# Call for a review of the SMF optical powers

Piers Dawe

Mellanox

Chart from [stassar\\_061417\\_3cd\\_adhoc-v2](https://www.stassar.com/061417_3cd_adhoc-v2)

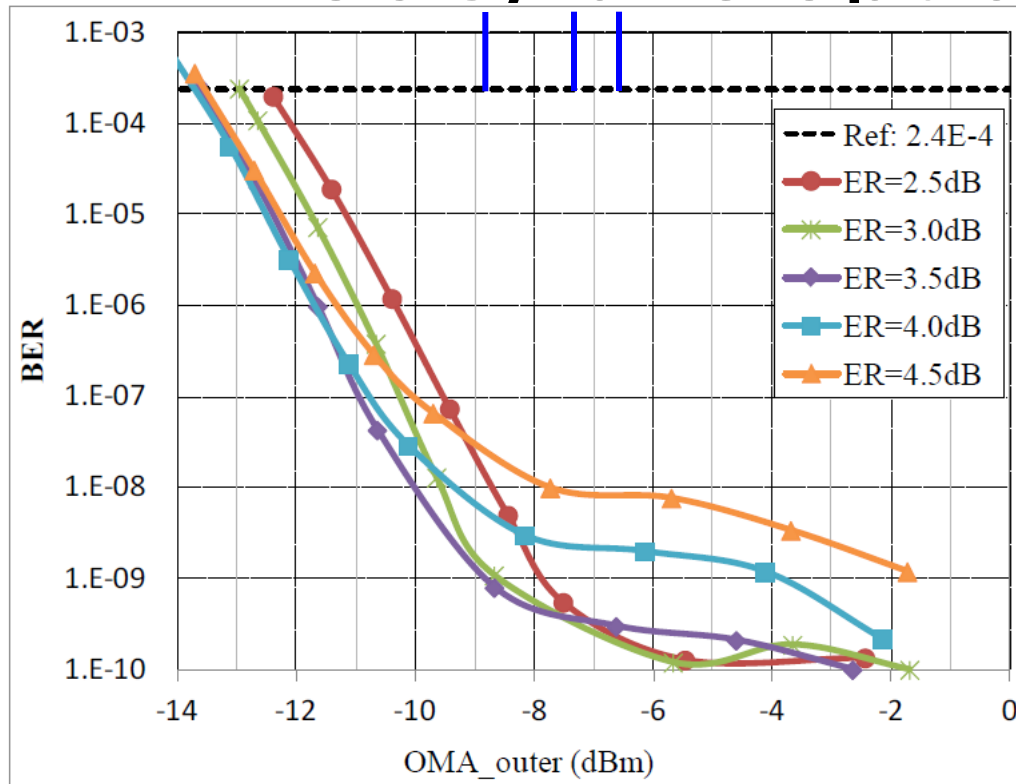
- Blue lines represent unstressed sensitivity (informative) for 50GBASE-LR (-8.8 dB), 50GBASE-FR (-7.3 dB) and 200GBASE-DR4 (-6.6 dB)
- There is possibly 4 dB margin for LR, 5½ dB for FR, 6 dB for DR4, plus the SECQ of this test transmitter
- This is much more encouraging than the early results with PAM4
  - Is this representative of performance during the life of the standard?

Chart from [mazzini\\_051017\\_3cd\\_adhoc](#)

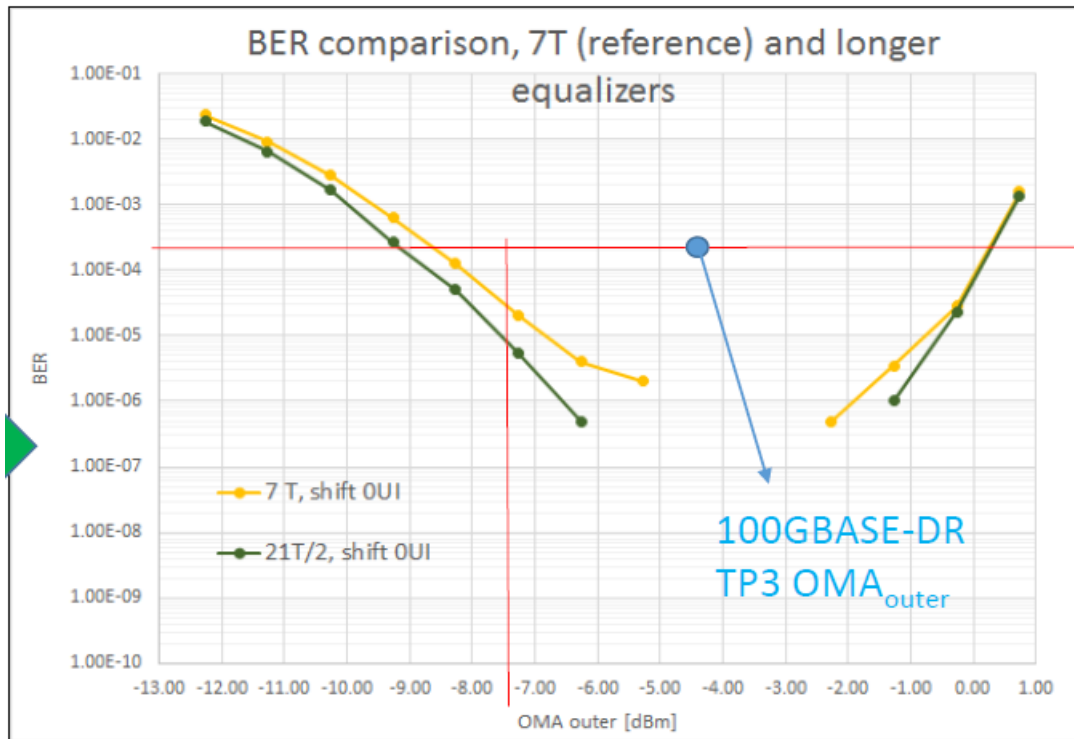
- Blue dot represents unstressed sensitivity (informative) for 100GBASE-DR and 400GBASE-DR4 (-4.4 dB)
- There is possibly 4 dB margin
- This is much more encouraging than the early results with PAM4
  - Is this representative of performance during the life of the standard?
